Drawing Objections

Attorney Docket No. MFCP.68661

FIG.11.

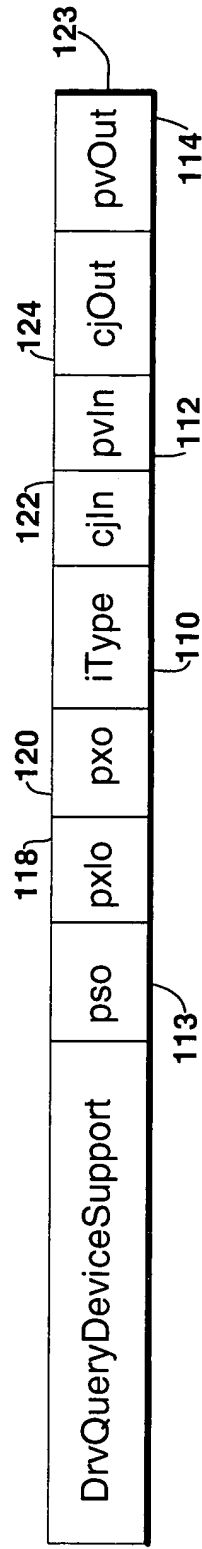
The drawings were objected to because reference character "124" in figure 11 referred to both "cjOut" and "DrvQueryDeviceSupport function." Applicants propose correcting the drawings by referring to the "DrvQueryDeviceSupport function" using reference numeral "123."

Regarding a similar duplication, Applicants note that reference numeral "114" was also duplicated in FIG. 11. Applicants suggest renumbering the first instance (referring to the "pso" field) to "113." Thus, the pso field becomes "113" instead of "114."

As described above, the specification has been correspondingly amended. A replacement figure that includes the proposed changes is included for the Examiner's approval.
